Building Facade Assessments and Recommendations

Building Façade Assessment Overview

c. 1912 photo of 10 East Morgan exhibits most of the details that currently are evident on the existing building. 100 years ago, the brick was not painted and the awnings were the more traditional operable canvas type that fit below the building cornice.

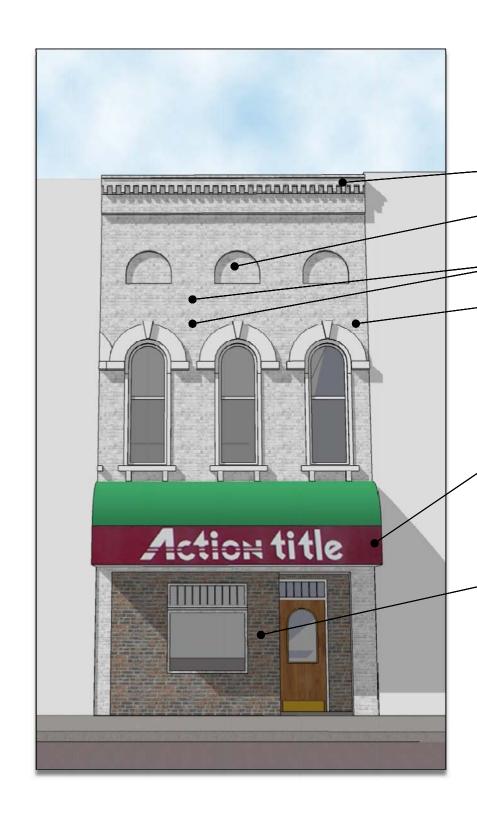
- Where there are attic openings, restore surviving original or recreate missing grilles and paint.
- Repair brick and mortar including cracks.
 - Option one: remove paint using nonabrasive method to protect old brick.
 - Option two: remove loose paint and repaint brick.
 Paint trim and face brick complimentary colors.
- Analyze structural condition of upper building façade. Repair cracks in brick.
- Remove awning that covers building details.
- Remove backlit plastic sign and install more appropriate façade or smaller hanging sign(s).
- Remove wood window infill and recreate clear glass storefront windows.
- Remove window air conditioners, infill square openings.
- Remove aluminum from bulkhead below storefront windows.

- Restore and relight the historic 'City of Mineral Water' sign on roof.
- Replace existing doors with historically accurate two panel, glass over lower kick panel doors.
- Repair existing wood storefront window frames and repaint. Install clear, energy efficient glass to fit within existing frames.
- Replace missing trees in tree grates along Main Street.
- Restore or recreate bulkhead.
- If desired, install fixed or operable canvas or mattefinish weather resistant cloth awning. Width of awning shall fit between column lines and should not extend the full width of the storefront. Awning valance shall not be fixed or rigid.

c. 1922 photo of 56 East Morgan Street. Note textured glass in transom above windows facing the alley.

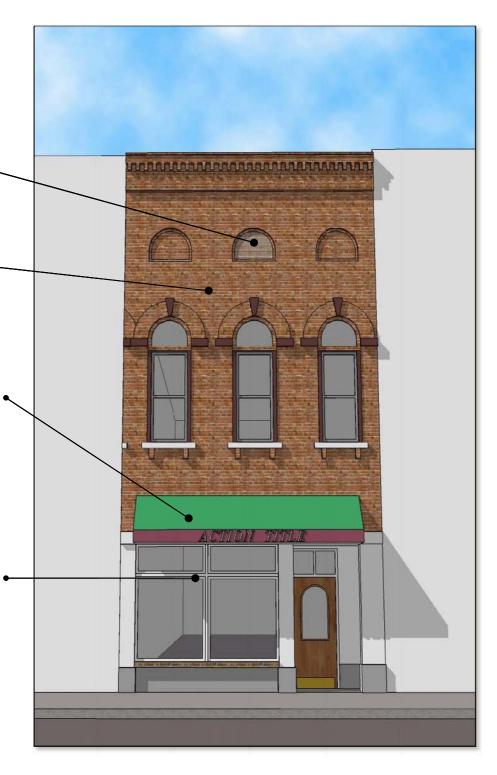
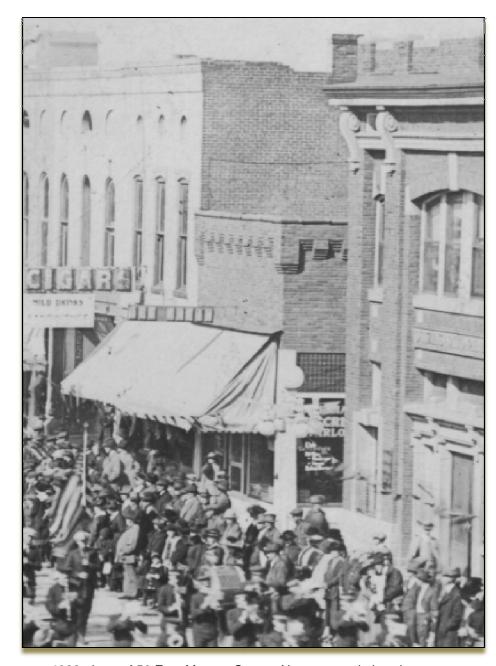
- Repaint or replace coping
- Remove plywood infill and install grilles with traditional pattern openings and bird screen behind grille.
- Remove old signage anchors; repair masonry.
- Remove paint with non-abrasive methods. Repair any loose masonry and mortar.

- Canopy style is not in keeping with style and proportion
 of historic canopy. Width of canopy would historically
 have fit within storefront column spacing and not extend
 across the entire width of building. Front valance should
 not be rigid or fixed. More appropriate canopy would be
 canvas or matte-finish weather proofed fabric.
- Remove modern brick façade and windows
- Install wood frame storefront and energy efficient glazing to match historic storefront detailing that would have maximized the glass. Use interior shades or drapes for privacy. Top of bulkhead below storefront glass should be no more than 30" above sidewalk grade.

This c. 1910 photo of 78 East Morgan shows rounded architectural elements along the top parapet walls which are no longer in place. This proposal does not replace those elements due to lack of architectural details and anticipated cost to reproduce.

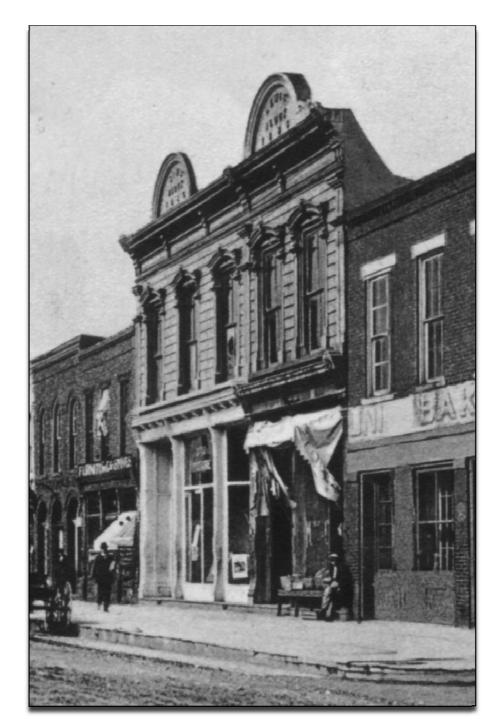
- Remove, clean, reset and seal existing clay coping tile.
- Clean and repoint brick.
- Remove existing hanging sign hardware.
- Repair brick where bolts are removed from brick and mortar.
- Replace metal flue on chimney.
 - Replace gutters and downspouts. If downspouts cannot be connected to city storm pipe, install boots at the base to direct water away from building.
 - Replace roof over door with inset doorway to provide a covered entrance without adding a roof structure.
- Remove wood infill from corner opening. Salvage any original transom glass or original storefront structure.
- Carefully remove wood and shingle awning and wood and brick storefront. Look for any original transom window glass or original storefront structure. Salvage and reuse all historic materials.
- Repair cementitious parge coating on base of building and repaint.

- New painted steel sign bracket with two sided hanging sign.
- New textured glass in transom. Glass color shall be clear or lightly tinted and allow filtered light into building.
- New wood window and door frame storefront inset slightly from iron corner posts.
- Open windows in alley to provide light to inner offices.
 Inset door, centered in storefront to provide covered entry that has an historic precedent in early 20th century commercial storefronts.
- New clear insulated storefront glass.
- Clean existing iron columns and paint.
- New wood bulkhead, height of bulkhead to match corner column base, approximately 20" above pavement.

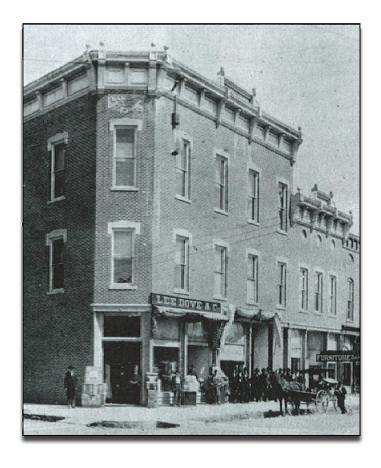
- Repair rotted wood window pieces, caulk and paint. Caulk perimeter of wood frames.
- Remove existing signage and hardware complete.
- Remove existing plywood infill panels.
- Remove existing aluminum window frames and single pane glass.
- Remove modern covering from column.

- Rebuild cornice to match historic cornice on the building to the east that was originally identical.
- Replicate original storefront with composite cement/wood frames and energy efficient glazing.
- Replace doors with wood frame doors that have historically accurate detailing and energy efficient glazing.
- Existing stone base can remain though it is not the original base. Optional composite cement/wood bulkhead below windows could be installed for a more historically accurate façade. Repaint columns, trim and storefront.
- Paint door and remove metal bars.

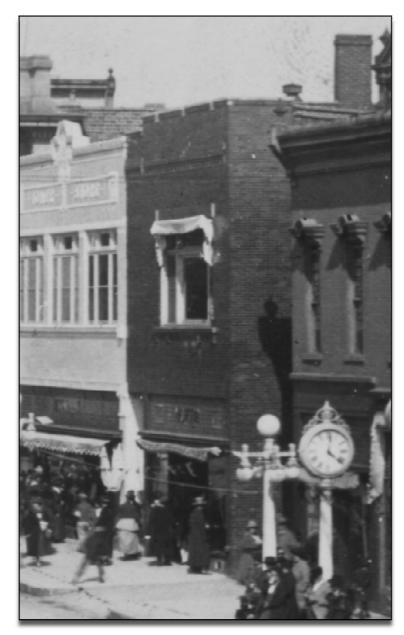
Remove brick bulkhead below windows.

Repair and replace missing or loose mortar.

Repair wood window frames and paint.

Remove canopy and wood siding covering what were transom windows. Remove existing materials carefully and salvage all original transom frames if still in place. Remove wood infill panels and small glass panels.

Remove paint on brick using non-abrasive methods.

Remove plastic sign.

Remove existing metal door. Remove existing entrance door.

- Clean and paint upper metal cornice.
- Recreate lower metal cornice to match historic details.
- Repair cornice and paint.

- Repair wood storefront frames and modify to accept clear, energy efficient glass.
- Repair and paint existing cast iron columns. Replace missing details.
- Install new wood storefront frames and clear, energy efficient glass.
- Install new painted wood doors.
- Replace wood bulkhead below storefront.
 - Install new painted wood bulkhead below windows.

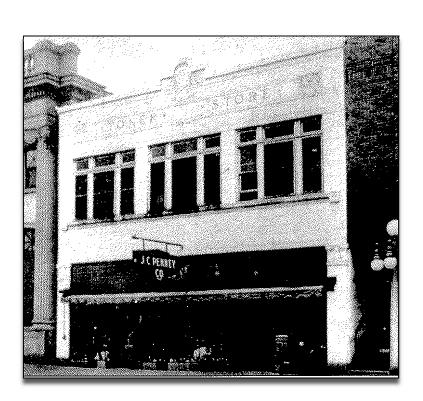
- Repair masonry mortar cracks; repoint to match existing mortar.
- Remove existing wood and shingle awning to reveal original transom window behind. Salvage and reuse any existing remaining textured glass.
- Remove wood siding and casement windows.
- Remove stone bulkhead below windows.
- Remove wood surrounding brick building columns at corners.

- Install textured glass transom to match historic condition.
- Install new painted wood storefront window and door framing with clear, energy efficient glass. Inset door for protection from weather. Use interior drapes or blinds for privacy.
- Repaint passage to second floor with color to match brick.
- Install painted wood bulkhead below storefront windows.
- Install new wood painted two panel door with glass above and wood below.
- Replace handrail in stairway. Repair lower wood steps.

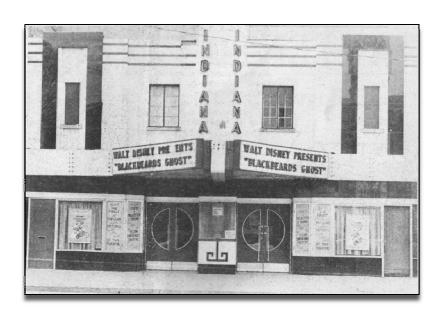
- Inspect and repoint all existing joints between terra cotta pieces to ensure water tightness of the façade.
- Repair large cracks in existing terra cotta panels which may require fabrication of replacement pieces.
- Remove existing louvers; rework ductwork inside building to maintain fresh air requirements.
- Remove existing signage and wood siding. Protect any remaining textured glass transom below. Remove paint that is on terra cotta panels adjacent to the existing sign.
- Repair holes and miscellaneous cracks in terra cotta.
- Remove existing roll-up awning, repair frame, add new canvas or matte finish weather resistant material and reinstall.
- Remove brick bulkhead below windows and replace with dark granite panels to match existing base at each end of building. Salvage existing granite if still in place underneath brick.

- New hanging sign to comply with the Historic Downtown District ordinance.
- Salvaged or recreated textured glass transom. Repair holes left by louvers with matching glass tile.
- Repair or replicate blue glazed terra cotta letters that spelled 'Toner Store'.
- Restore decorative terra cotta detail to original condition.
- Existing storefront frames and glass may remain but if new energy efficient glass is installed, a darker color window frame should be installed.
- Install new dark granite panel bulkhead below storefront windows.

The above c. 1916 photo bears little resemblance to the later 1939-40 renovation shown in the photo below. Many of the 1939-40 building details are still recognizable, and it's this time period and detail recommended for façade renovations.

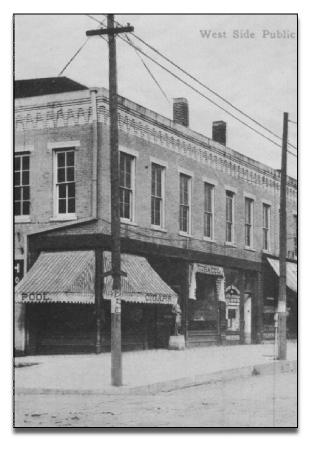
- Remove existing building signage.
 - Remove signage and electric conduit complete.
- Remove shutters.
- Clean, re-glaze broken or missing window glass, remove rust from steel window frames and repaint.
- Replace window glass.
- Remove existing awning and framework.
- Remove stone veneer that is not typical for older building façade material.
- Remove non-historic steel door.

- Install black glass tile to match 1939-40 façade.
- Paint horizontal bands to match historic façade.
- Paint window frames same color as building façade.
- Recreate aluminum theater type cornice and front overhang. Overhang can act to protect door and for business signage.
- Repair, repaint and reuse historic doors.
- New exterior materials to match original appearance.
- Install black glass tile bulkhead below storefront windows to match historic façade.
- Install new painted wood door with clear glass above solid kick plate.
